Fox Canyon Groundwater Management Agency

**Board Regular Meeting
of
May 27, 2026**

14. **Adopt the Las Posas Valley Basin Optimization Yield Study – (Returning Item)**
RECOMMENDATIONS: (1) Receive a Watermaster staff presentation on the Las Posas Valley Basin Optimization Yield Study and related Recommendation and Response Reports; and (2) Adopt the proposed Las Posas Valley Basin Optimization Yield Study.

FIGURE 3-4

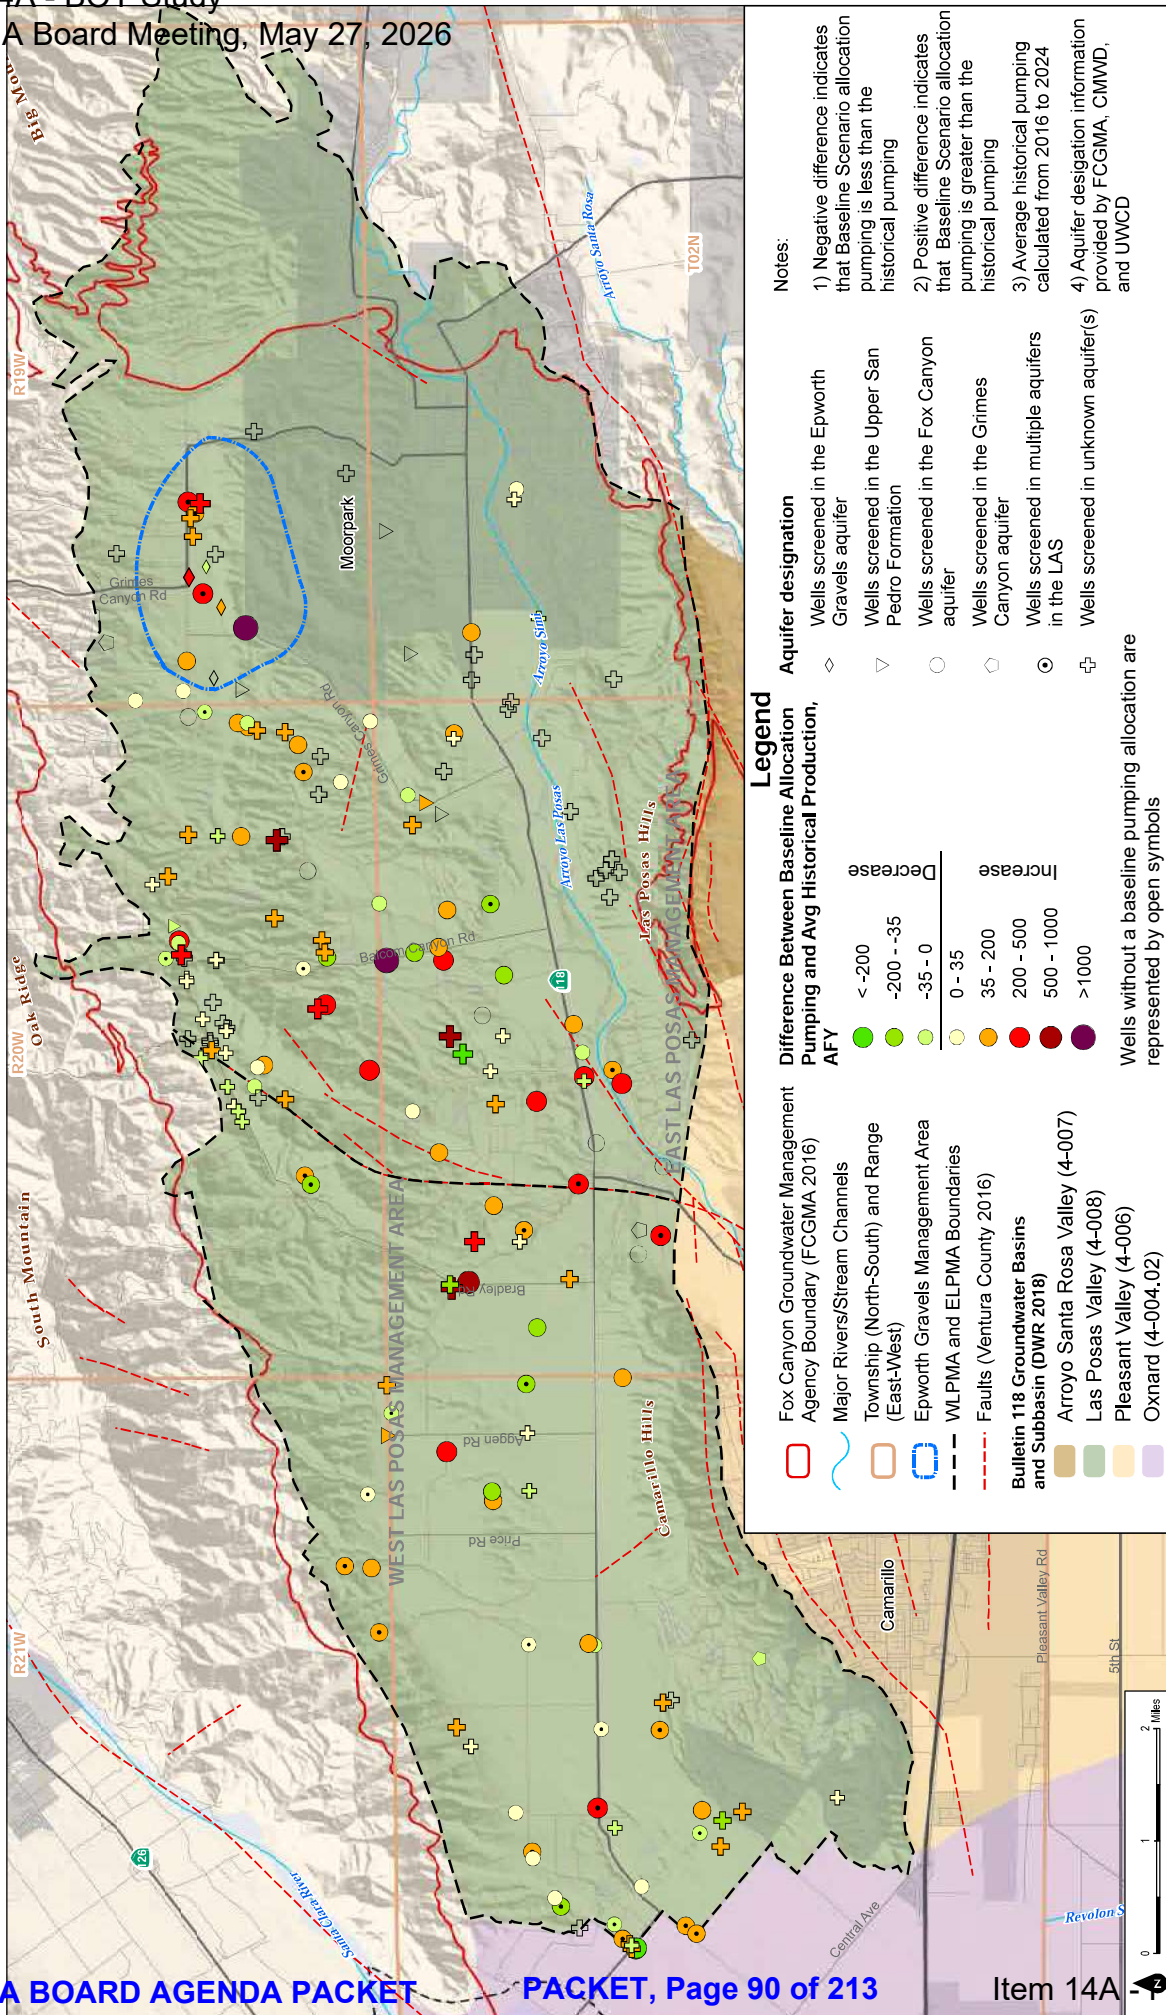
BA-20	Bob Abrams	Technical	Wording	12	3.2.2.2	<i>The differences between the Baseline Scenario production rate and the average groundwater production from water years 2016 to 2024 are shown in Figure 3-4.</i>	Should state explicitly if these differences are increases or decreases, here and on Figure 3-4. e.g., text could say increases and decreases are shown on Figure 3-4. Figure legend could indicate which ranges equate to increases and which to decreases.
BA-21	Bob Abrams	Technical	Clarification	13	3.2.3.1	<i>If, during water year 2024, these Water Right Holders pumped less than average from the Epworth Gravels Management Area wells, the baseline pumping distribution in the BOY Study Baseline Scenario</i>	There should be some kind of text explaining that this is unavoidable and HOW THIS WILL be accounted for in the Operating Yield/
BA-22	Bob Abrams	Technical	Clarification	13	3.2.3.1	<i>Groundwater production at the Baseline Scenario rates was determined not to be sustainable in the ELPMA because simulated groundwater elevations at five Key Wells fell below the minimum threshold groundwater during the 47-year model run (Figure 3-6).</i>	Were these simulated hydrographs also shifted, as in Figure 3-5. If so there should be a note on the figure. Also, I think you need to say somewhere in the main text that you have more faith in simulated groundwater <u>changes</u> , than simply the simulated elevations.

BA-20	Wording	12	3.2.2.2	<i>The differences between the Baseline Scenario production rate and the average groundwater production from water years 2016 to 2024 are shown in Figure 3-4.</i>	Should state explicitly if these differences are increases or decreases, here and on Figure 3-4. e.g., text could say increases and decreases are shown on Figure 3-4. Figure legend could indicate which ranges equate to increases and which to decreases.
BA-21	Clarification	13	3.2.3.1	<i>If, during water year 2024, these Water Right Holders pumped less than average from the Epworth Gravels Management Area wells, the baseline pumping distribution in the BOY Study Baseline Scenario would extrapolate this single year of reduced pumping over the entire 47-year model time period. The result is continuously rising simulated groundwater elevations that do not reflect the historical production patterns from the aquifer.</i>	There should be some kind of text explaining that this is unavoidable and HOW THIS WILL be accounted for in the Operating Yield/

FIGURE 3-5
 Epworth Gravels Key Well Hydrograph: Well 03N19W29F06S
 Basin Optimization Yield Study for the Las Posas Valley Basin

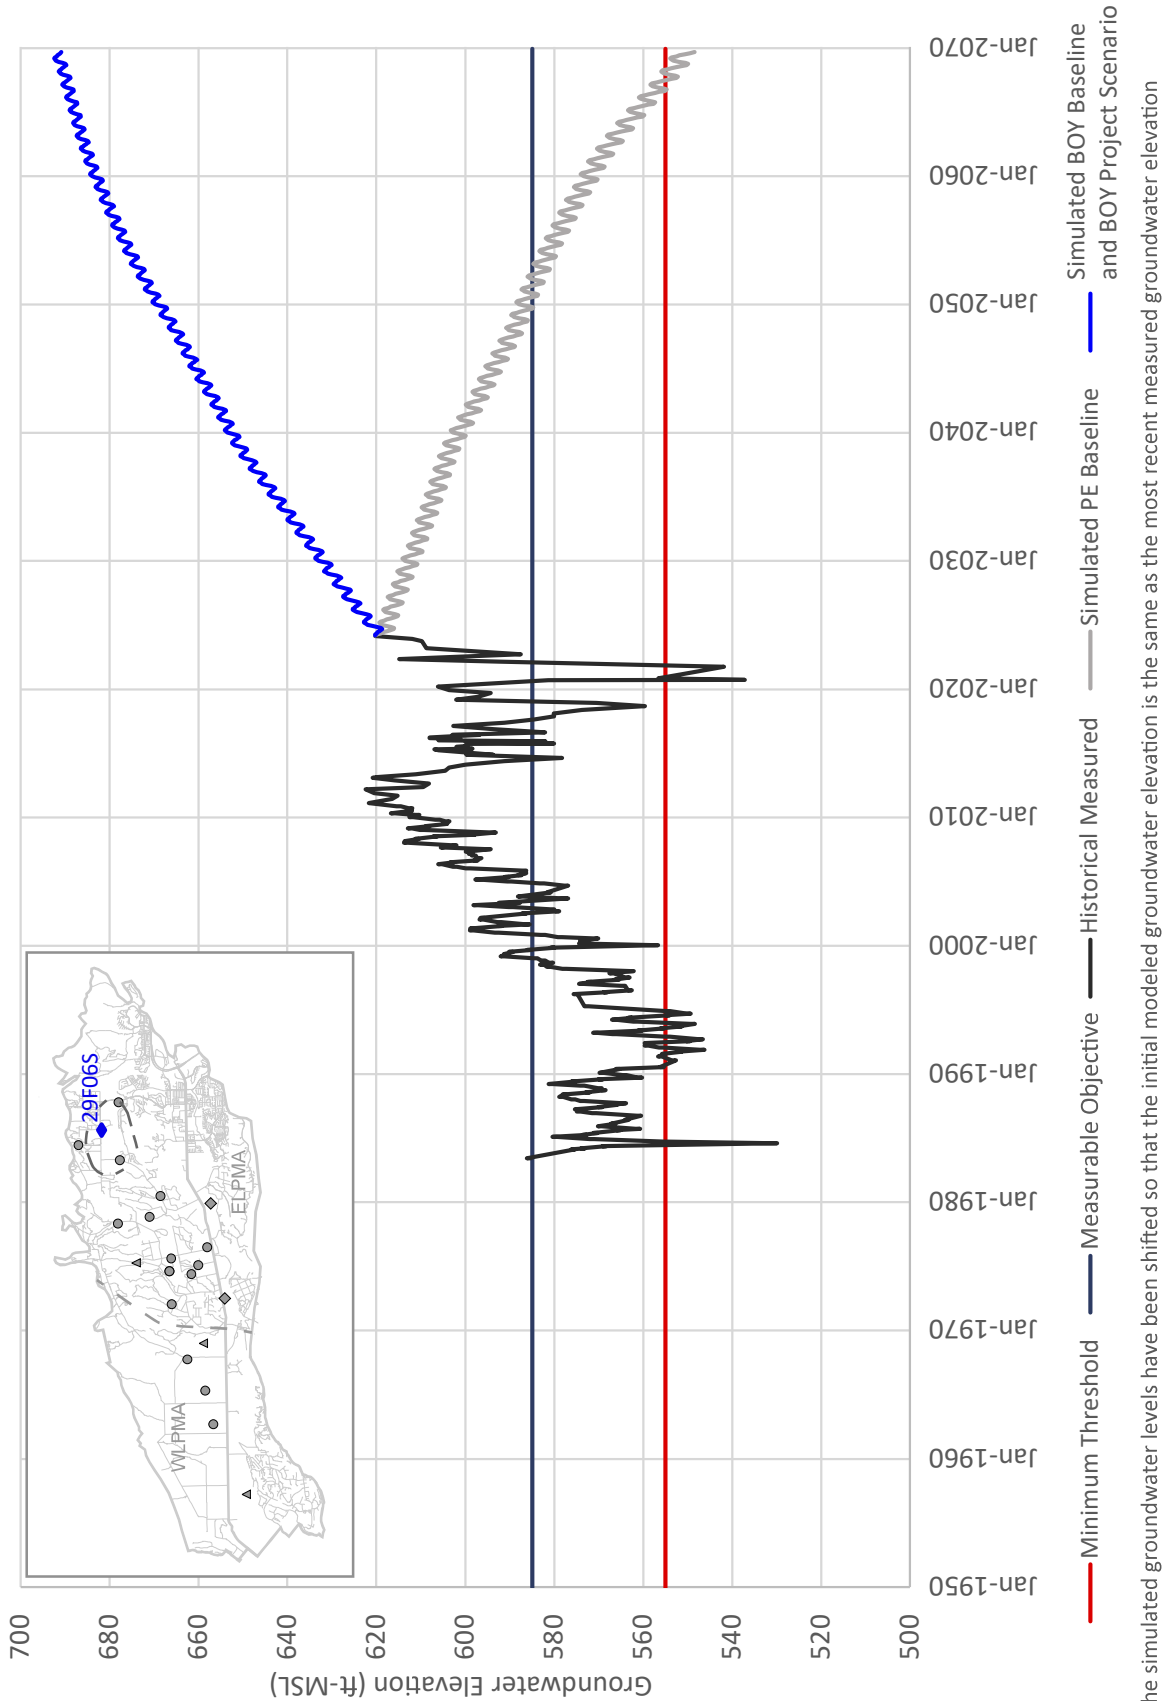
DS-2	DSchwabauer	General Editorial	needed validation on Epworth Gravels	13	3.2.3.1	<i>In the Epworth Gravels Management Area, simulated groundwater elevations rose throughout the 47-year model time period (Figure 3.5).</i>	The beginning sentence about the Epworth Gravels is very misleading. It is well documented from historic pumping records that the Epworth Gravels water level has in general declined over the past 50 years, I say this as a pumper who has witnessed water level decline in our own wells in the Epworth.
DS-3	DSchwabauer	General Editorial	impacts unknown to date	13	3.2.3.1	<i>First, not all groundwater producers with wells in the Epworth Gravels Management Area received an allocation in the Judgement (Figure 3-4).</i>	The full impact of this allocation change is unknown; at this time there has not yet been a ruling by the court.
DS-4	DSchwabauer	General Editorial	validation of the In-lue project	13	3.2.3.1	<i>When wells were rested in the Epworth Gravels Management Area, the groundwater elevations recovered. Both the GSP and the First Periodic Evaluation anticipated that adaptive management would occur, through pumping reductions in Epworth Gravels Management Area wells, as necessary, to maintain groundwater elevations between the minimum threshold and measurable objective.</i>	From my perspective, these ending sentences clearly encapsulate the water usage patterns of the Epworth Gravels Management Area. The key takeaway from this resting of pumping of the Epworth Gravels clearly illustrates the benefit of the In-lue water purchase program. In my opinion, this demonstrates the high value of In-lue water usage to the basin, which benefits everyone in both the East and West Las Posas.

BB-10	Bryan Bondy	Technical	Epworth Gravels Mgmt. Area	13	3.2.3.1	"not all groundwater producers with wells in the Epworth Gravels Management Area received an allocation in the Judgment (Figure 3-4)."	Two comments. (1) Estimates of Epworth Gravels Mgmt. Area extractions that are not included in the analysis should be provided (i.e. groundwater producers w/o a Judgment allocation) for context. This can be estimated from historical extractions reported to FCGMA. (2) Is the Epworth Gravels Management Area the only management area that has groundwater producers w/o a Judgment allocation? If no, estimates should also be provided for those management areas for context.
BB-11	Bryan Bondy	Technical	Epworth Mgmt Area Sustainable Yield vs. Rampdown Pumping	18	3.4.1.1	"The estimated sustainable yields of the Epworth Gravels Management Area and the ELPMA were approximately 500 and 1,450 AFY higher, respectively, than the simulated groundwater production in the Basin-wide Rampdown scenario."	This difference for Epworth Gravels Mgmt Area is significant on a percentage basis. Text should be added to explain why this large of a difference exists.

DS-2	DSchwabauer	General Editorial	needed validation on Epworth Gravels	13	3.2.3.1	<i>In the Epworth Gravels Management Area, simulated groundwater elevations rose throughout the 47-year model time period (Figure 3.5).</i>	The beginning sentence about the Epworth Gravels is very misleading. It is well documented from historic pumping records that the Epworth Gravels water level has in general declined over the past 50 years, I say this as a pumper who has witnessed water level decline in our own wells in the Epworth.	Commenter is correct regarding historical groundwater levels. The BOYS notes that the projected future groundwater levels simulated by the numerical model are not anticipated to reflect actual conditions in the Epworth Gravels. The text explains the two reasons why the model does not accurately predict future groundwater levels in the Epworth Gravels.
DS-3	DSchwabauer	General Editorial	impacts unknown to date	13	3.2.3.1	<i>First, not all groundwater producers with wells in the Epworth Gravels Management Area received an allocation in the Judgement (Figure 3-4).</i>	The full impact of this allocation change is unknown; at this time there has not yet been a ruling by the court.	Comment noted.

FIGURE 3-13
Differential Rampdown Scenario Groundwater Elevation Hydrograph Map

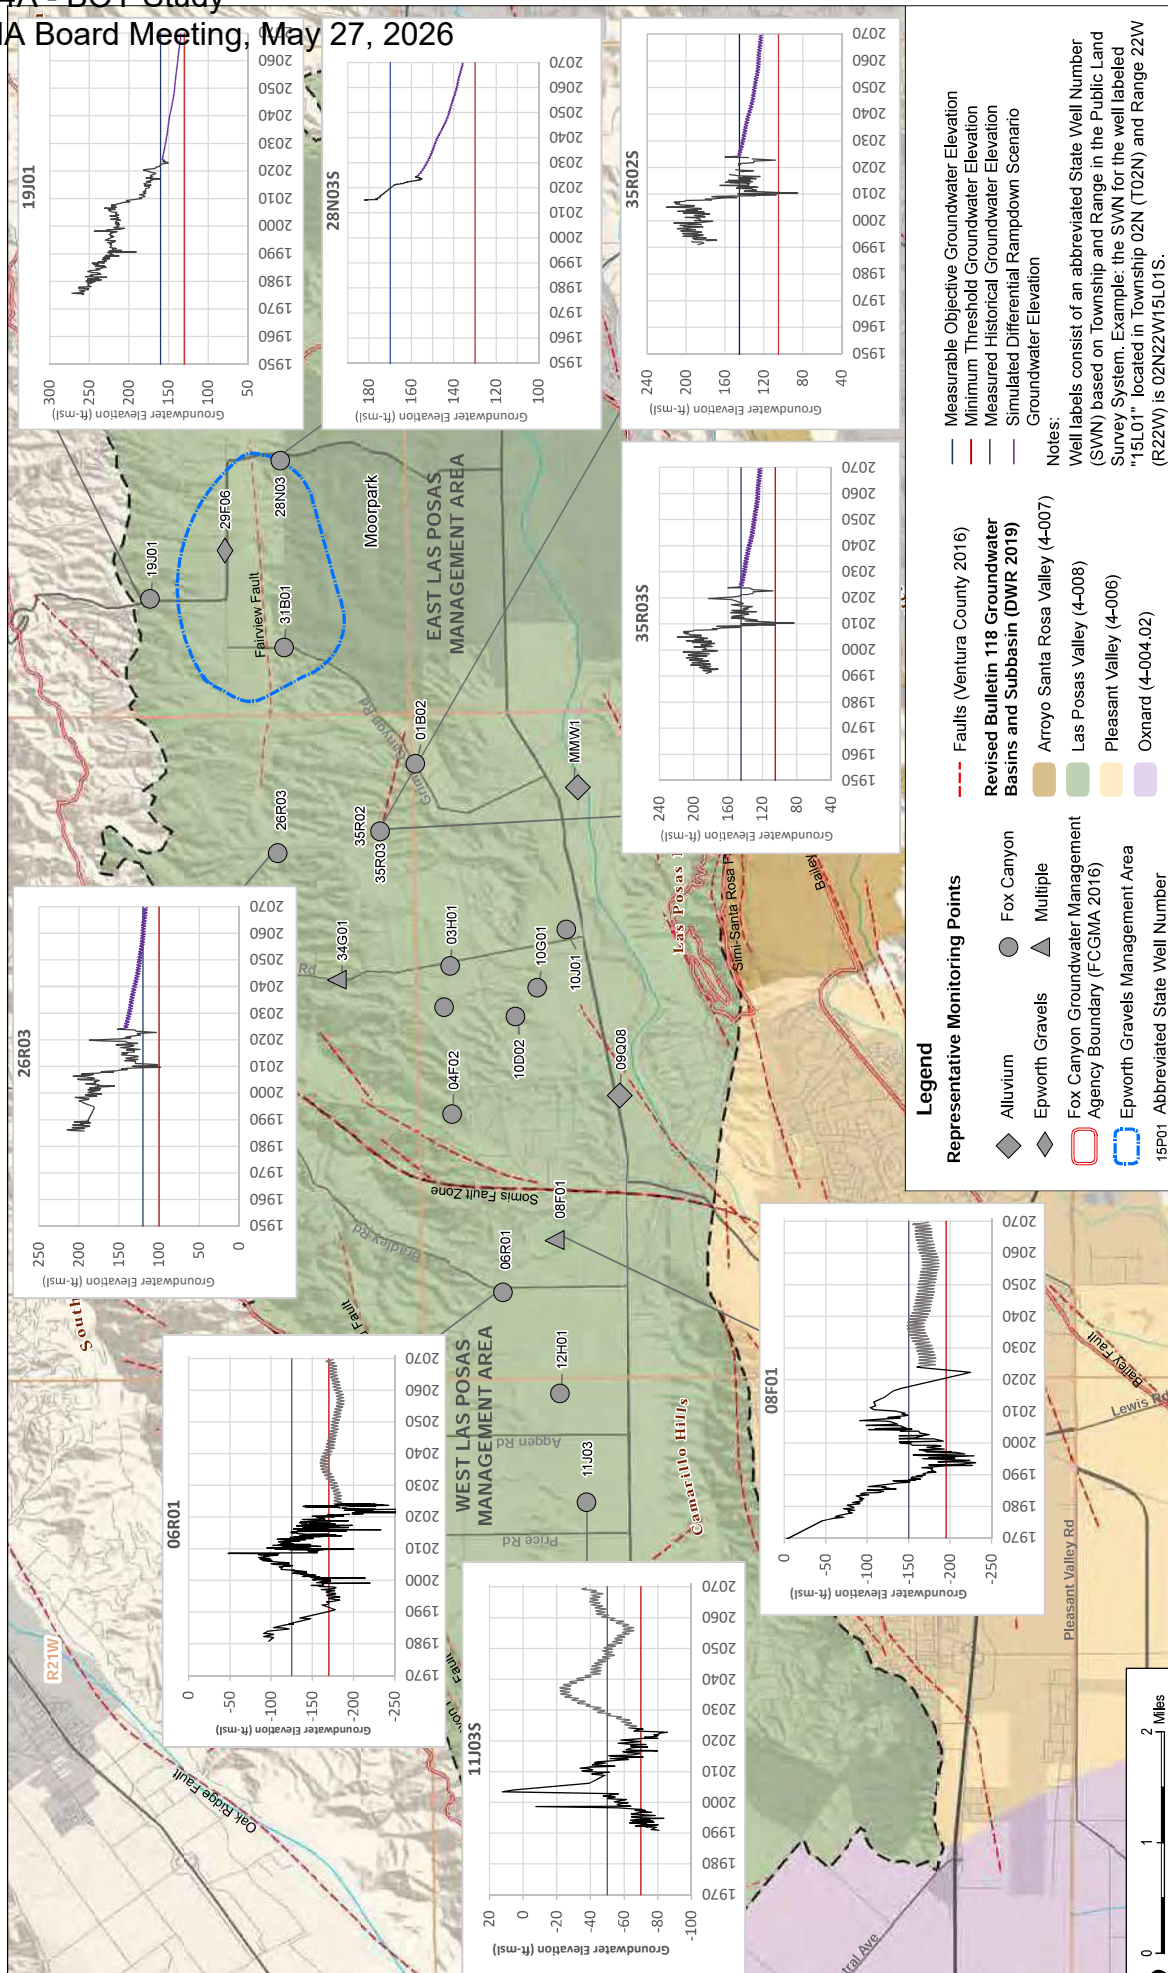
- Provide additional discussion of the differential rampdown scenario results in the EGMA, specifically addressing continuing declines in groundwater levels shown on Figure 3-13.

- As discussed above, the Operating Yield, and Rampdown, in the Epworth Gravels Management Area should be managed together with the ELPMA.
- As noted in Section 3.4.2.2, the hydrograph for the Epworth Gravels Management Area Key Well is in Appendix B, not shown in Figure 3-13.
